On behalf of Con Edison Clean Energy Businesses, Inc., enclosed please find an updated submission for the Yorktown A Solar Farm Project. It is our understanding that this project has been placed on the agenda for the March 22nd, 2021 Planning Board meeting for consideration. The project involves the installation of ground mounted photovoltaic panels and battery storage on a vacant forested parcel west of Foothill Street and north of Lockwood Road.

This letter is also provided in response to a memorandum we received from the Town of Yorktown Engineering Department, dated November 9, 2020. Provided below are the comments from the memorandum followed by our responses in bold.

YORKTOWN A SOLAR FARM SITE PLANS

GRADING / SWPPP PLAN

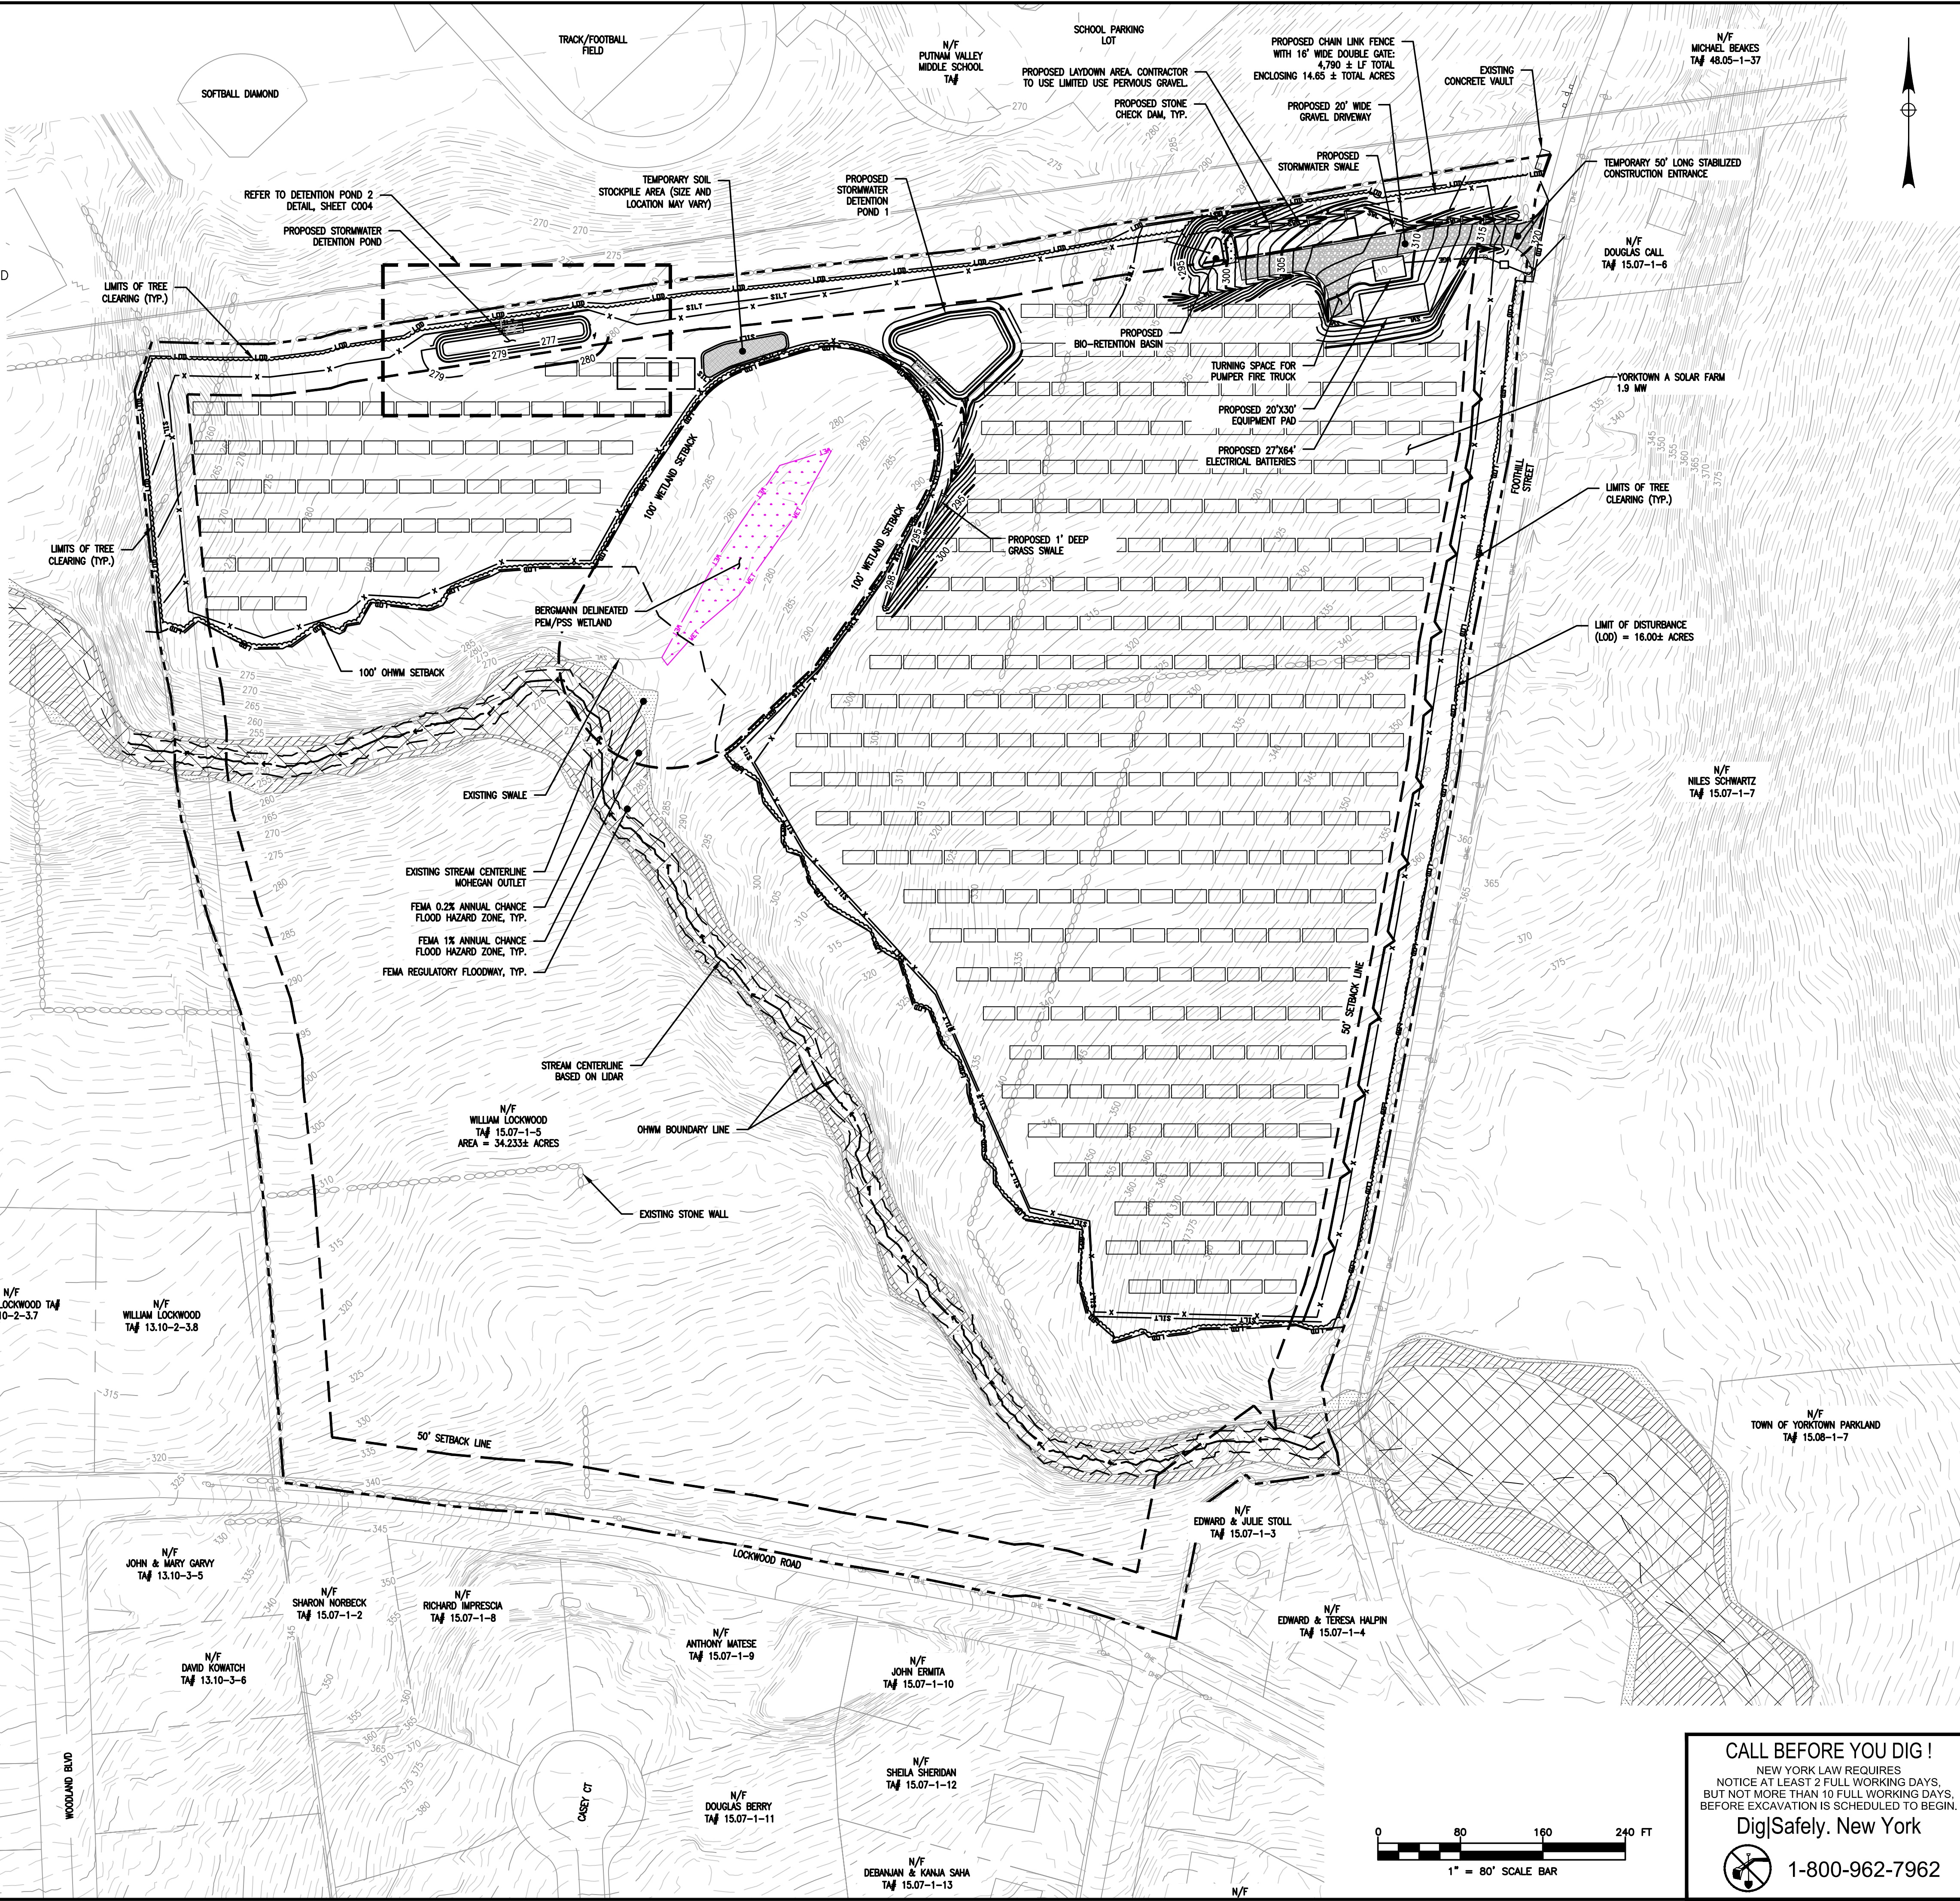
In order to complete our technical review, additional information is needed to fully describe the scope of land disturbance, the purpose and function of stormwater detention ponds, the calculations to show if there is an increase in stormwater runoff, the tree removal survey and tree mitigation plan. We also think it would be very beneficial if the Applicant provided photo renderings of the existing site conditions and the proposed condition.

Appendix C of the SWPPP, entitled “Erosion and Sediment Control Plan(s) and Details (ESC),” addresses practices such as the use of silt fence, check dams, establishing vegetative cover, installing matting on steep slopes, etc. We are concerned that the noted ESC measures may not be sufficient to control the increased runoff resulting from clear-cutting and grubbing the 5.8-acre steep, heavily treed section of the Lockwood property that discharges stormwater runoff directly onto the adjacent school property. We would like the applicant to evaluate the use of siltation basins and evaluate using a more phased approach to construction in this area.

- **The stormwater Pollution Prevention Plan (SWPPP) is included as an attachment to this letter and provides all information regarding the land disturbance, the purpose and function of the stormwater detention ponds as well as the calculations pertaining to the stormwater treatment and storage necessary to meet the requirements of the New York State Department of Environmental Conservation and the Town of Yorktown. In addition, the limits of tree clearing are shown on the Site Plans, a tree mitigation plan was included in our previous submission and photo renderings of the existing site conditions and proposed site conditions is included as an attachment to this letter.**

**LANDSCAPING & PLANTING
FOR MITIGATION PLAN**

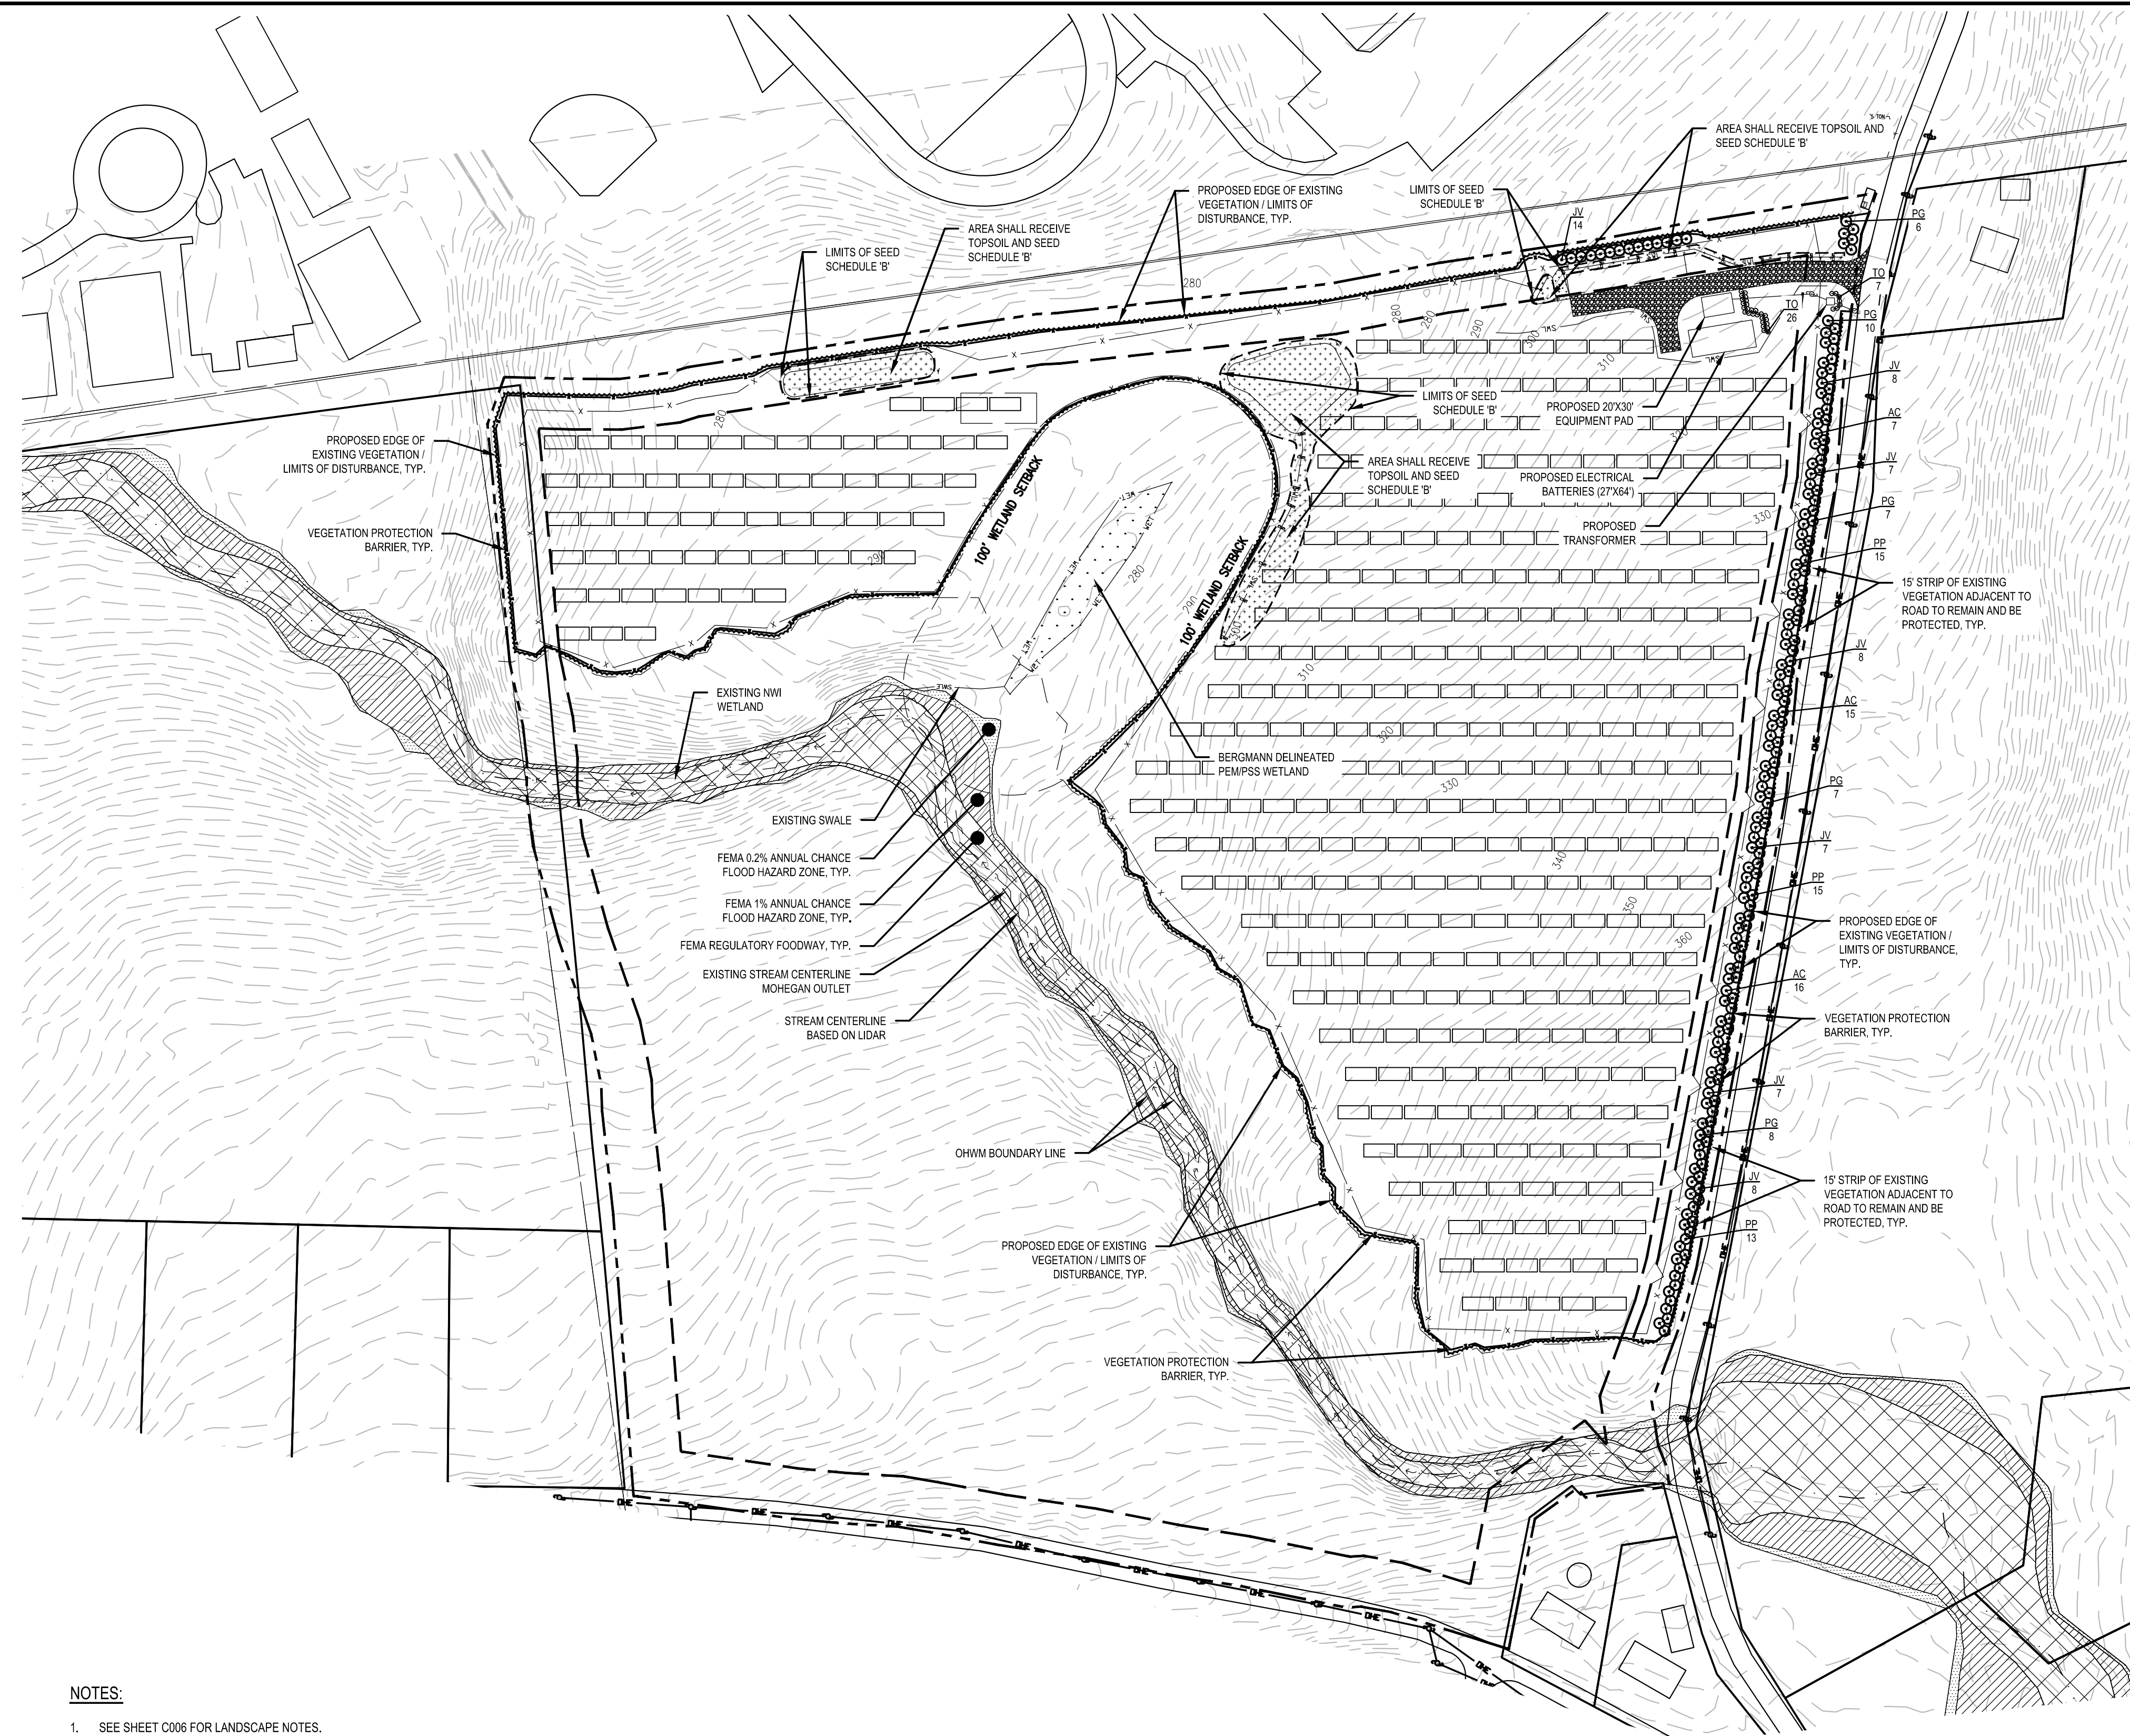
1. The Putnam Valley Central School District has serious concerns about the visual impact the proposed solar farm will have on its viewshed. Currently, trees within and outside of the 5.8-acre watershed on the Lockwood property will be removed and replaced with near grade level solar panels. The applicant should provide the school with a 3D computer-generated video of how the view from different locations on school grounds and in the buildings will change.

Foothill Street and the surrounding area have a wooded character which could be compromised by the proposed solar farm. The site plans do not show a count of the trees to be removed or how the solar farm would be visually buffered from surrounding roads and properties.

Accordingly, Con Edison CEB has worked with a registered landscape architect to develop a dense and extensive planting plan to enhance the natural screening already there. That plan, with a cost of \$160,000, provides for an additional 212 plantings, averaging over six feet in height when installed on Day 1 and growing to an average height of nearly 14 feet in Year 5.

Again, see the Landscaping and Plantings for Mitigation Inventory and Cost Estimate attached, along with the Year 5 average growth rate chart developed on information from the Arbor Day Foundation annexed thereto.
